## DRAINAGE AND TRANSPORTATION INFORMATION SHEET

**Project Title:** Universe View Strip Mall **Building Permit #** \_\_\_\_\_ **Hydrology File #** \_\_\_\_\_

Re: Universe View Strip Mall, TCL letter of response

**TRAFFIC CIRCULATION LAYOUT**

**DO NOT ENTER SIGN**

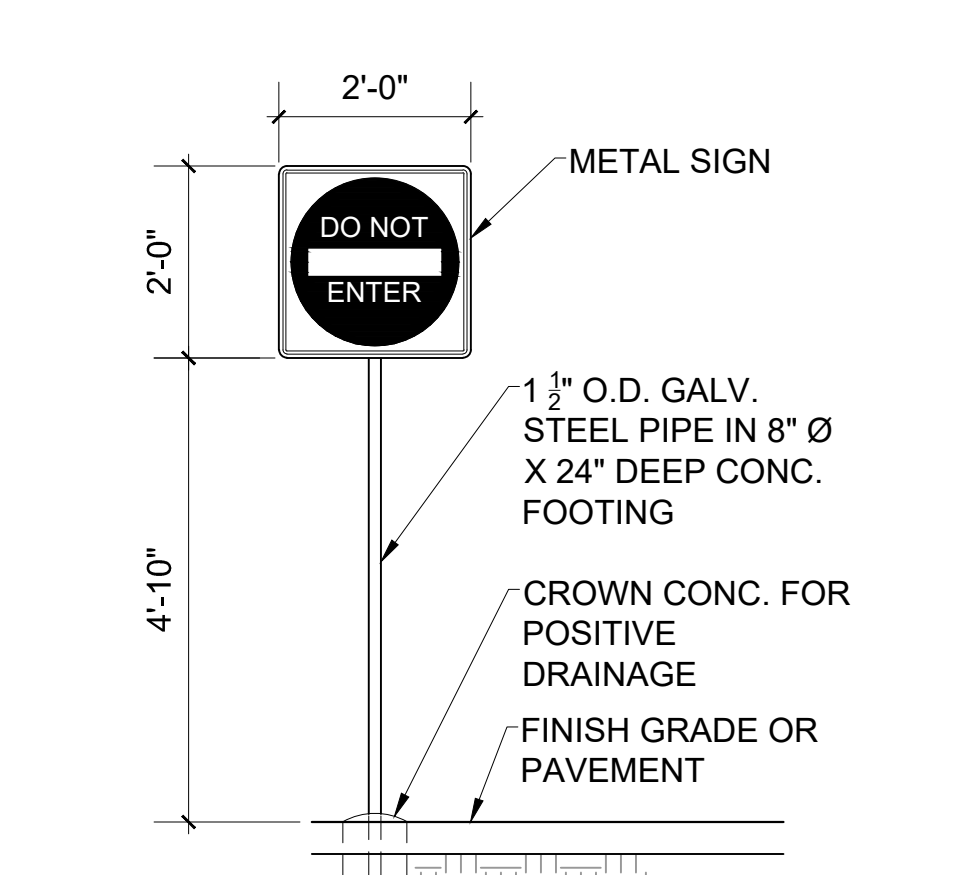
12. All one-way drives shall have "One Way" and "Do Not Enter" signage and pavement markings. Please show detail and location of posted signs and striping. **Signs and pavement markings added.**

**PAVING SECTION**

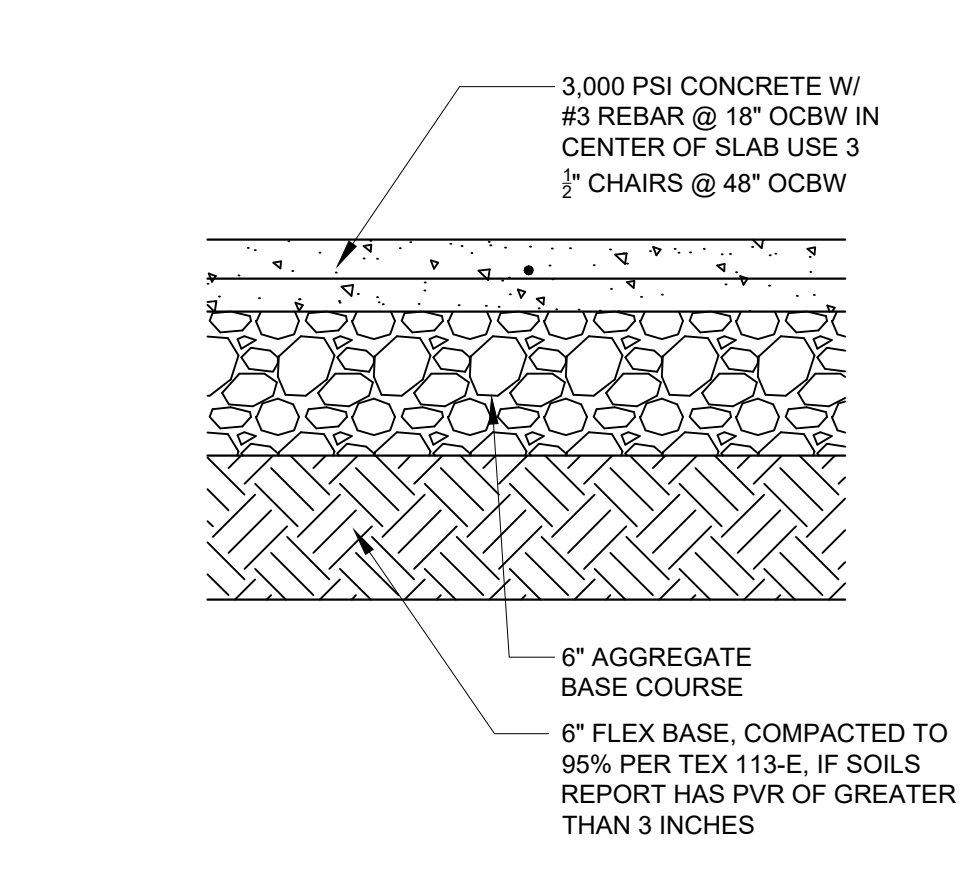
11. It is not apparent what type of pavement surface is being proposed. A hard driving surface will be required as part of this proposed project for parking area and drive aisles. **Pavement section added.**

**SITE PLAN**

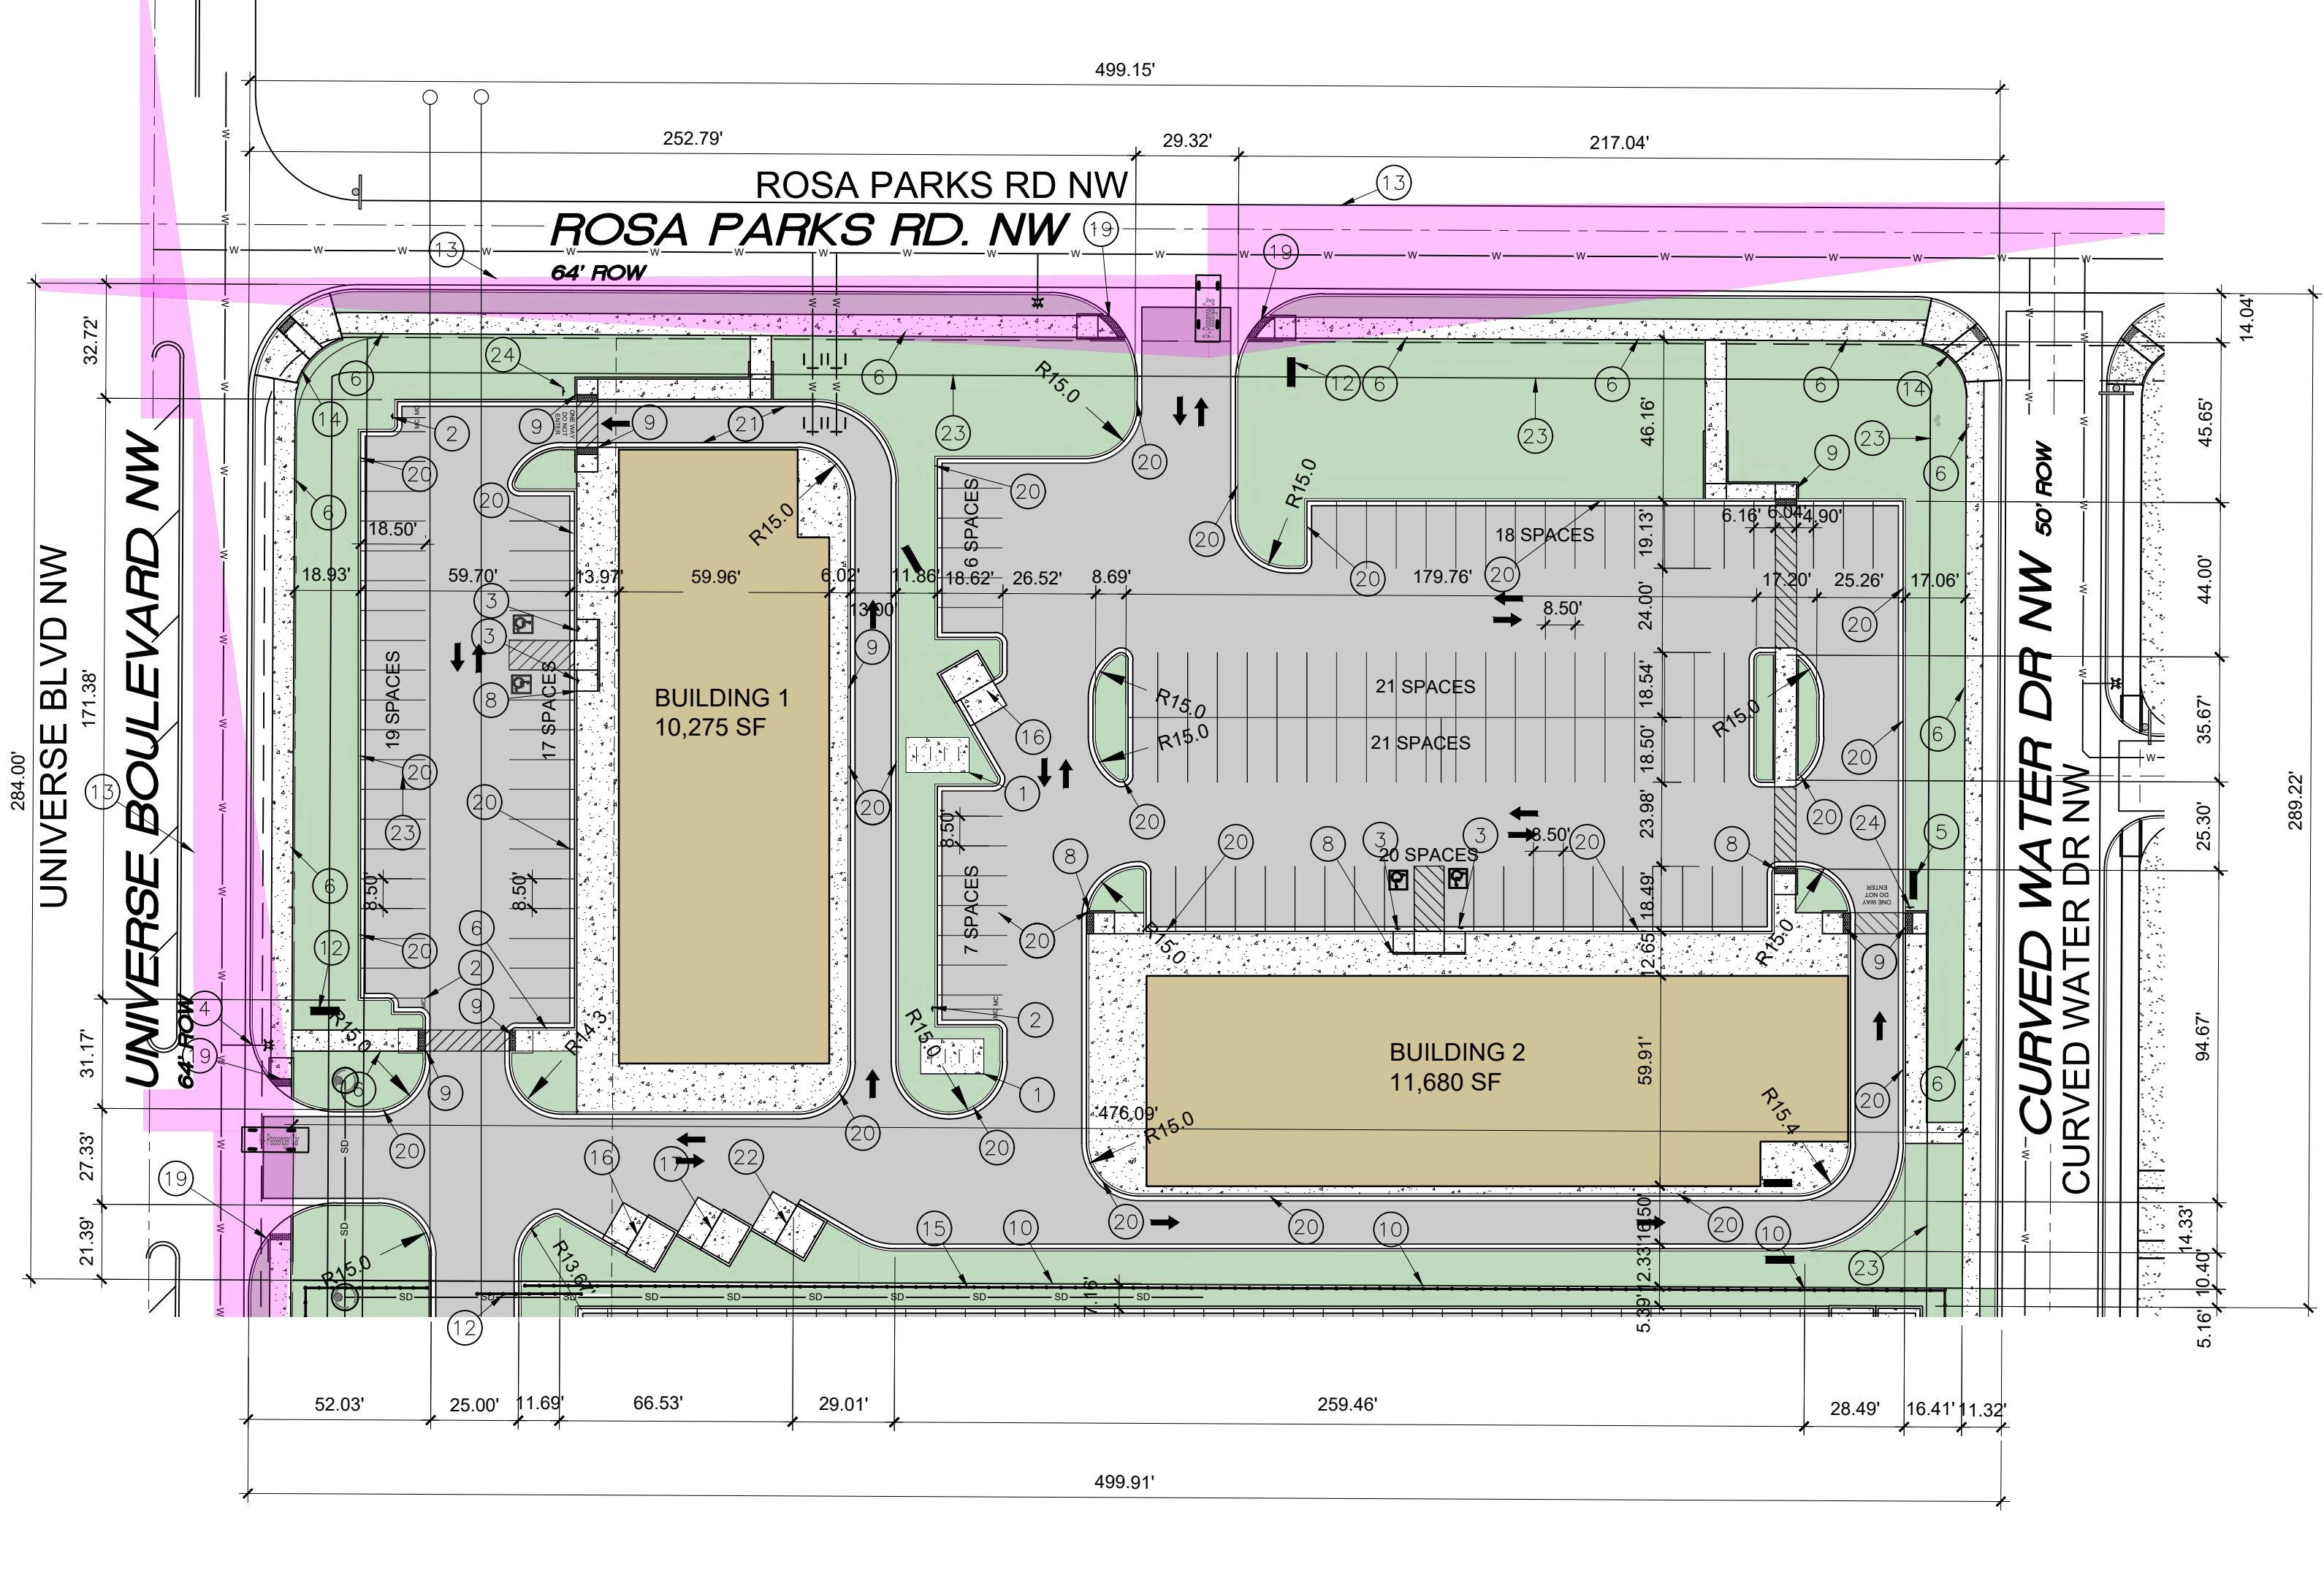
1. Identify all existing access easements and rights of way width dimensions. **Added reference keyed note 23.**
2. Identify the right of way width, medians, curb cuts, and street widths on Universe Blvd, Rosa Parks Rd, and Curved Water Dr. **Added to sheet.**

5. Please build a curb return design for the site accesses off Universe Blvd. and Rosa Parks Rd. show the radii on the site plan. Per the DPM, a curb returns design need to be built on Collectors and Arterials and for development with 50 or more required parking spaces. **Added to sheet.**

6. Show on the site plan the width for the standard parking spaces. **Added.**
7. Please clarify the pedestrian pathway width on the site plan. **Additional dimensions provided.**

8. Please clarify the correct location for keynotes 15, and 16. **References corrected.**
9. Please clarify, is this a one-way drive aisle? **This is a one-way drive aisle directional arrows, pavement markings and Do Not Enter signs added.**

<b>UNIVERSE VIEW SUBDIVISION PHASE 1</b>		<b>TITLE: SIGNING &amp; STRIPING UNIVERSE BLVD</b>	
Design Review Committee	City Engineer	Mo./Day/Yr.	Mo./Day/Yr.
City Project No. <b>709790</b>	Zone Map No. <b>D - 10</b>	Sheet <b>58</b>	Of <b>68</b>
<b>PROJECT NO. PR-2020-004596</b>		<b>SHEET</b>

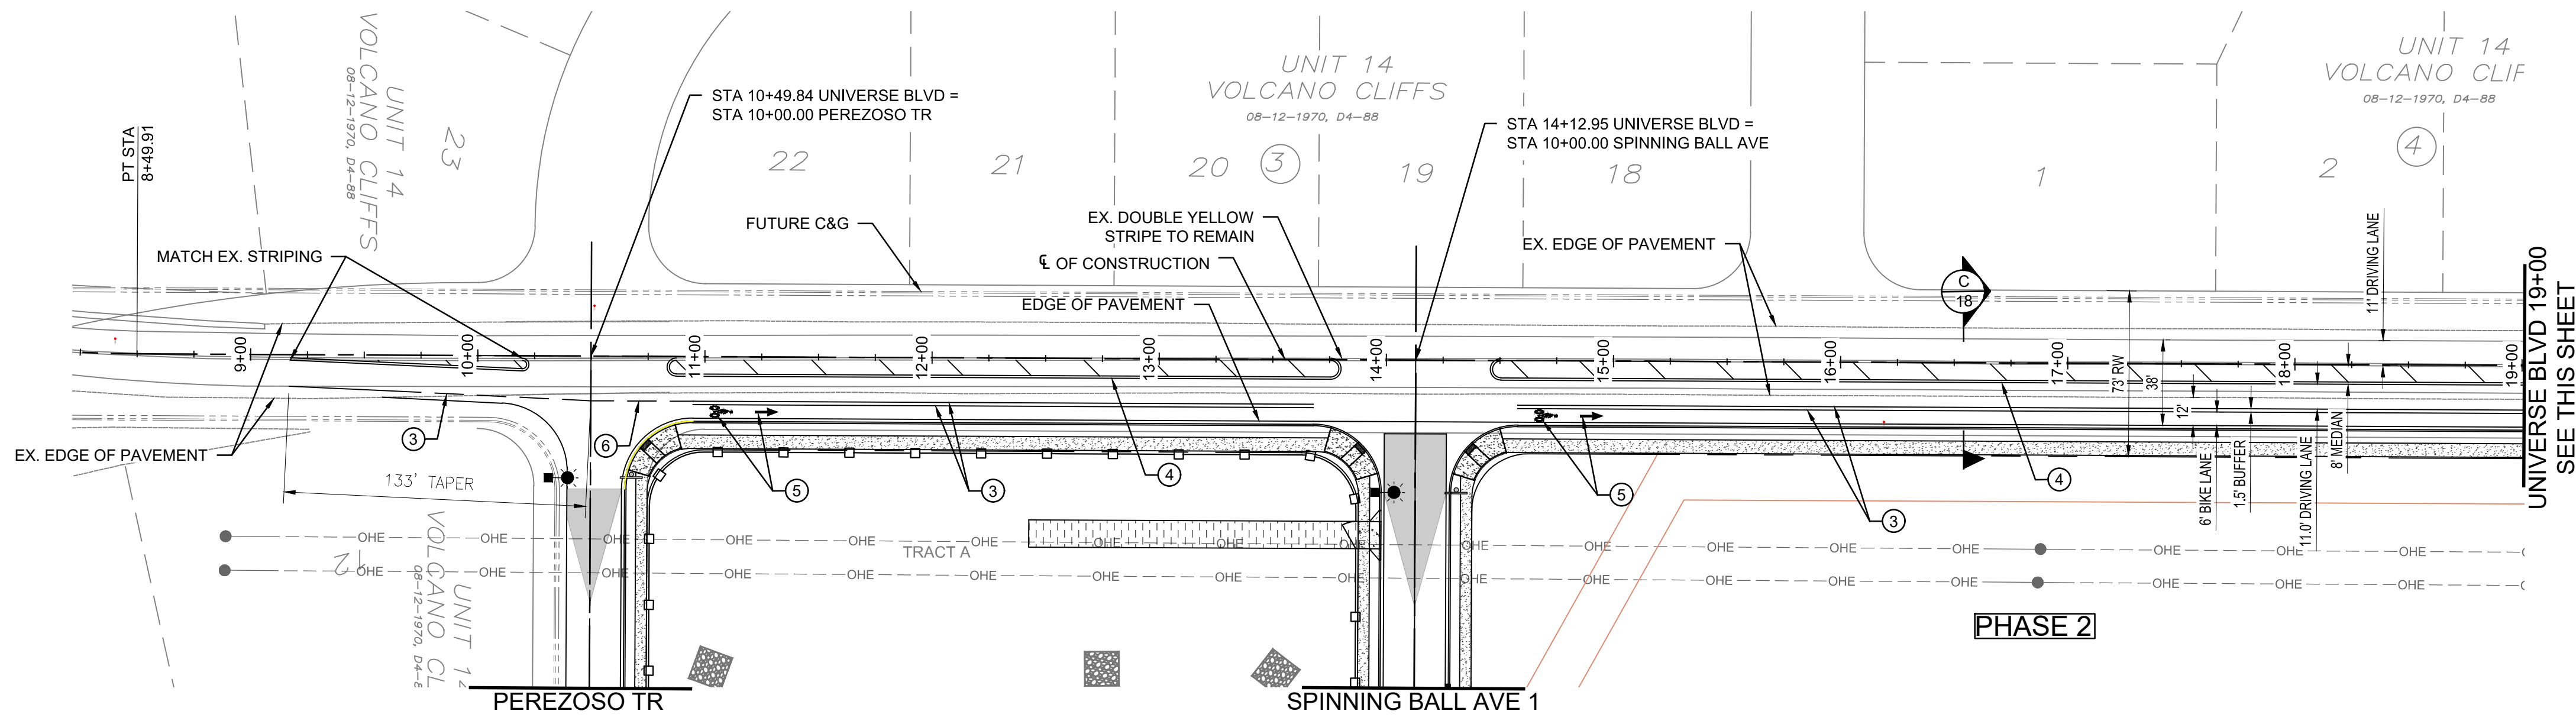
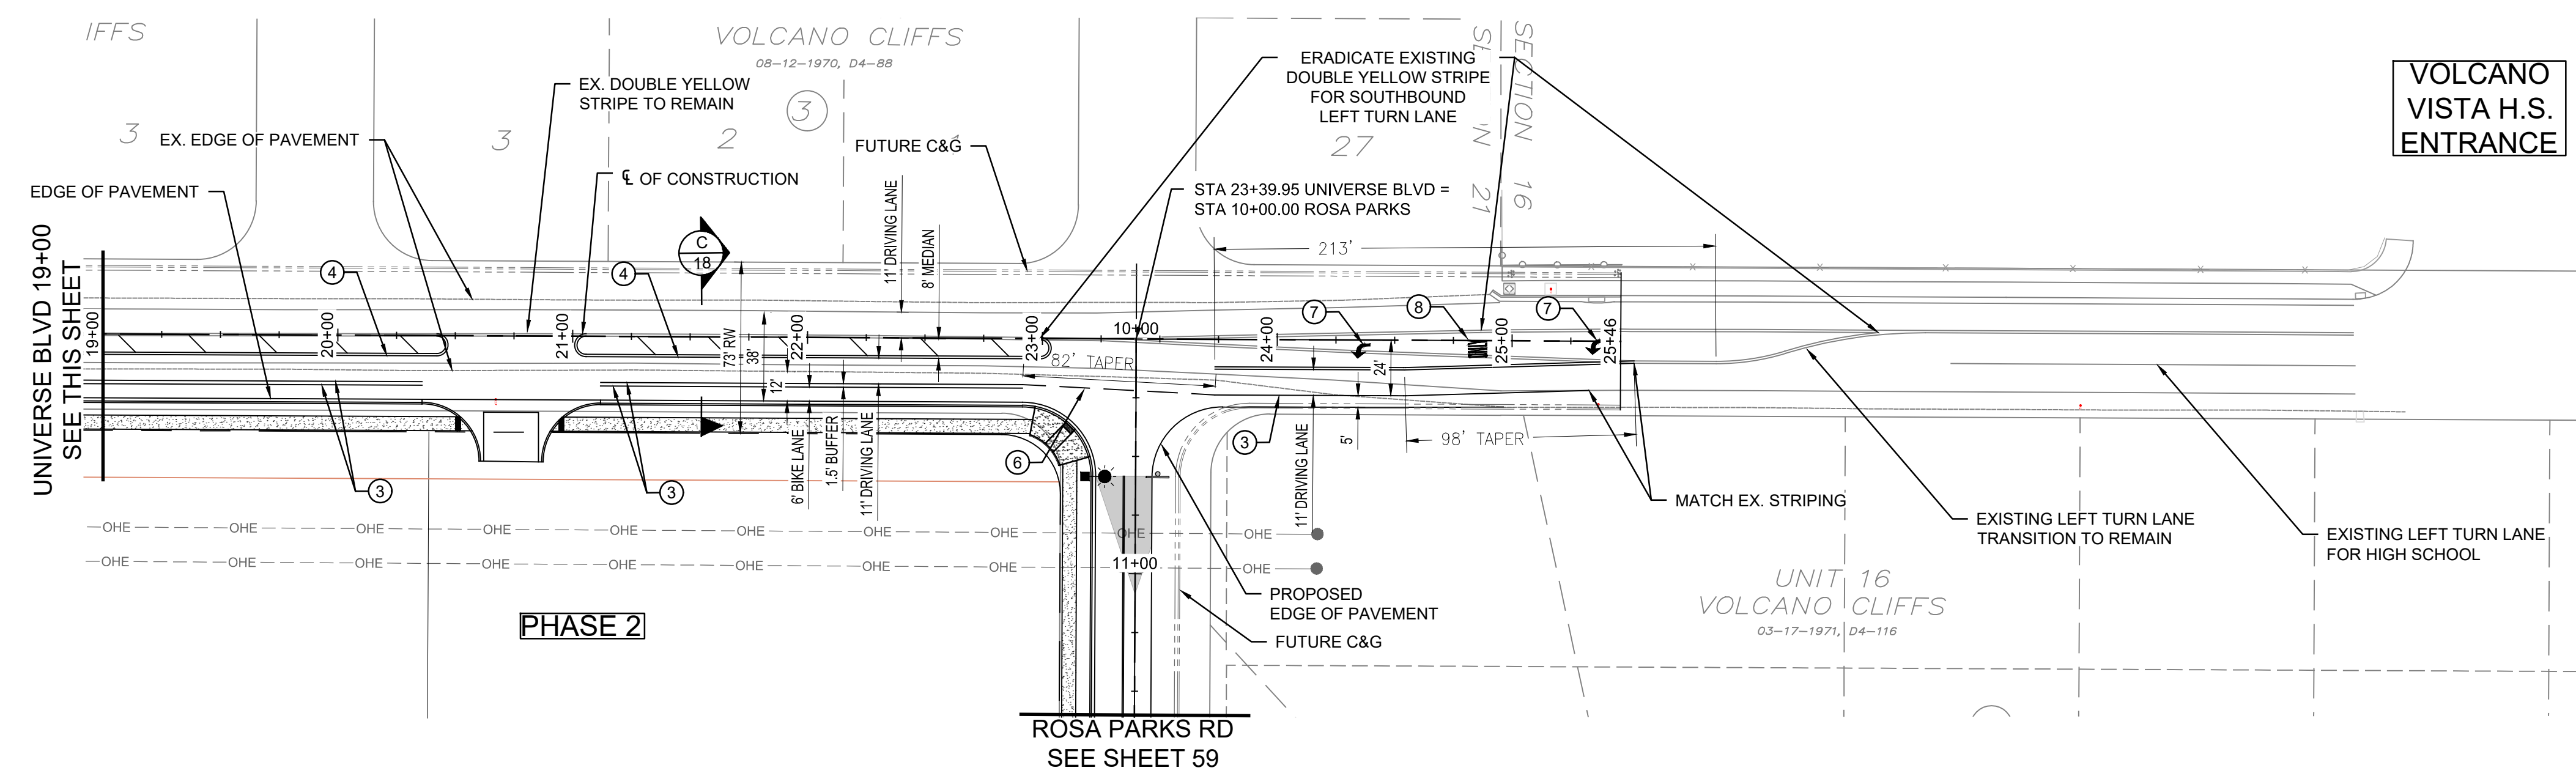
3. Please provide Infrastructure List showing the improvement of Rosa Parks Rd and Curved Water Dr. **Provided, see attached.**
4. Per approved Traffic Impact Analysis letter, please show on the site plan the improvement on the intersection of Universe Blvd. and Rosa Parks Rd. (Build a southbound left-turn lane, 240 feet long with a 300'-150' reverse curve transition). **Provided, see attached.**
